MFN 07-041
January 25, 2007

Subject: MELLA Plus LTR NEDC-33006P, Revised Response to RAIs AOO 3, 9, 10, and 17 (TAC No. MB6107)

Revised Responses to RAIs AOO 3, 9, 10, and 17

Figure 17-1 BSEP 1 and 2 MELLLA+ Operating Range Power-Flow Map (NEDC-33063P)

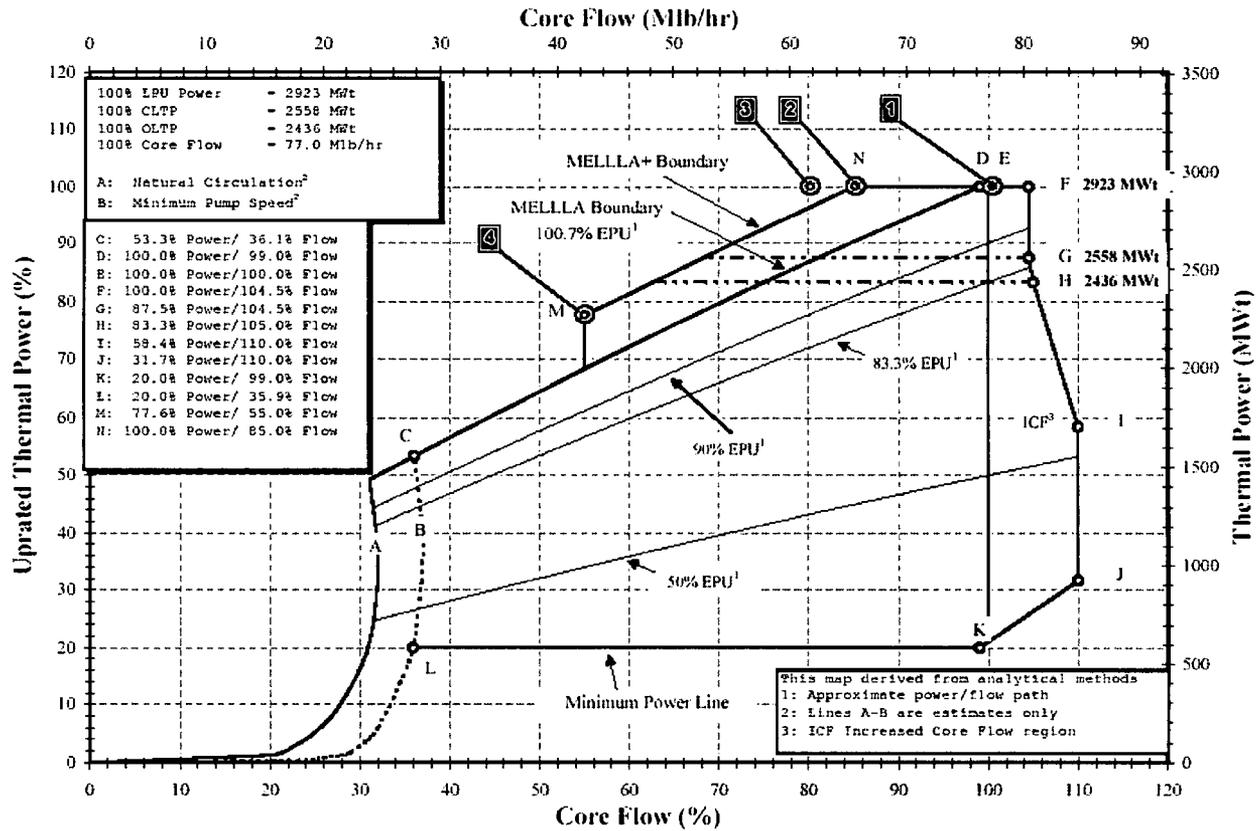
- a. SLMCPR. It is possible that the impact on the critical heat flux (CHF) phenomena may be higher at the off rated or minimum core flow state points. Is the SLMCPR value provided in the SLMCPR amendment requests and reported in the TS based on the rated conditions? If so, justify why the SLMCPR is not calculated for state points other than the rated conditions. Quantitatively demonstrate that the SLMCPR calculated at the minimum 80 percent and 55 percent state points would be lower than the SLMCPR calculated at the rated conditions. Use power profiles and core designs that are representative of the EPU/MELLLA+ conditions. Discuss the assumptions made. Include the Brunswick EPU/MELLLA+ application in your sensitivity analyses.

- b. SLMCPR at EPU/MELLLA+ Upper Boundary. The SLMCPR at the non rated conditions (EPU power/80 percent CF) could be potentially higher than the SLMCPR at rated conditions, explain how "state point-dependent" SLMCPR would be developed and implemented for operation at the EPU/MELLLA+ condition. Use the Brunswick EPU/MELLLA+ application to demonstrate the implementation of "state point-dependent" SLMCPR.

The Brunswick 1 Cycle 15 core design was selected to illustrate the effects of off-rated power and flow conditions on the SLMCPR calculation for EPU/MELLLA+ applications. The proposed MELLLA+ power / flow map for the Brunswick nuclear units is shown in Figure 17-1. SLMCPR values were determined for three power / flow state points along the upper boundary of the map and for the rated power / lowest flow point being considered for generic MELLLA+ operation (100%P / 80%F), as defined in Table 17-1.

Case (1) was the rated condition (state point "E" in Figure 17-1) SLMCPR evaluation that was used in the Reload Licensing Analysis for Brunswick 1 Cycle 15. Case (2) determined the SLMCPR for the rated power / lowest licensed flow condition (state point "N" in Figure 17-1). Case (3) determined the SLMCPR for rated power / lowest flow for the generic MELLLA+ application, for comparison purposes. Case (4) determined the SLMCPR for the highest off-rated power / lowest off-rated flow statepoint along the Brunswick 1 MELLLA+ upper boundary (point "M" in Figure 17-1).

Cases (2) and (4) correspond to points N and M, respectively, on the MELLLA+ boundary, as seen in Figure 17-1. The SLMCPR calculations for these two cases used a fixed set of control
